UNITED STATES PATENT AND TRADEMARK OFFICE

10/563,553

DETAILED ACTION

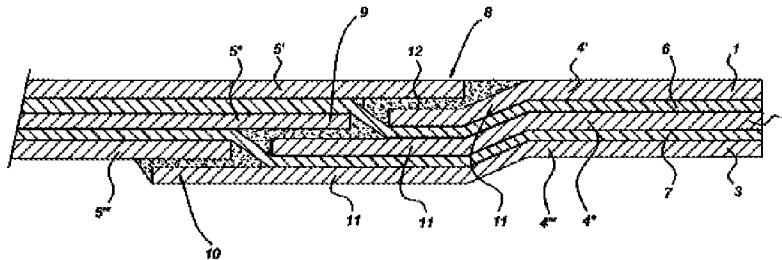
14. The phrase “wherein in a second region separate from said first region said two metal layer sections are at a same level of the laminate” in claim 17, lines 7-9 is vague and indefinite since it is unclear what is the “level of the laminate”, thus making it unclear what is the level of the two metal layers and whether the metal layers are at the same level as each other since one is bent.

FIG. 9

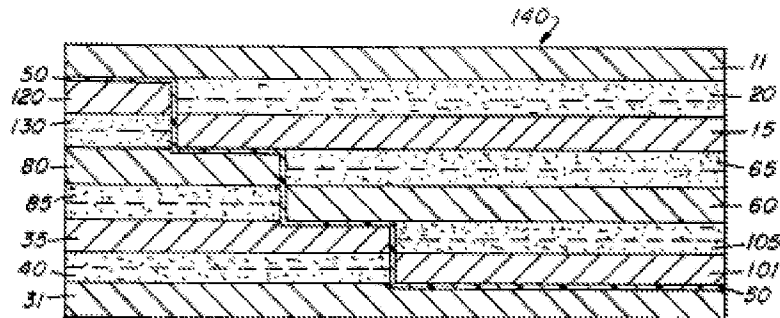
However, Lambing ('771) teaches a laminate wherein the plastic bonding layer comprises a fibre layer that has been impregnated with an adhesive (*See col. 5, ll. 34-37, col. 3, l. 36 and FIGs 9 and 3, #50.*) for the purpose of providing a structure having high tensile strength (*See col. 2, ll. 29-33.*).
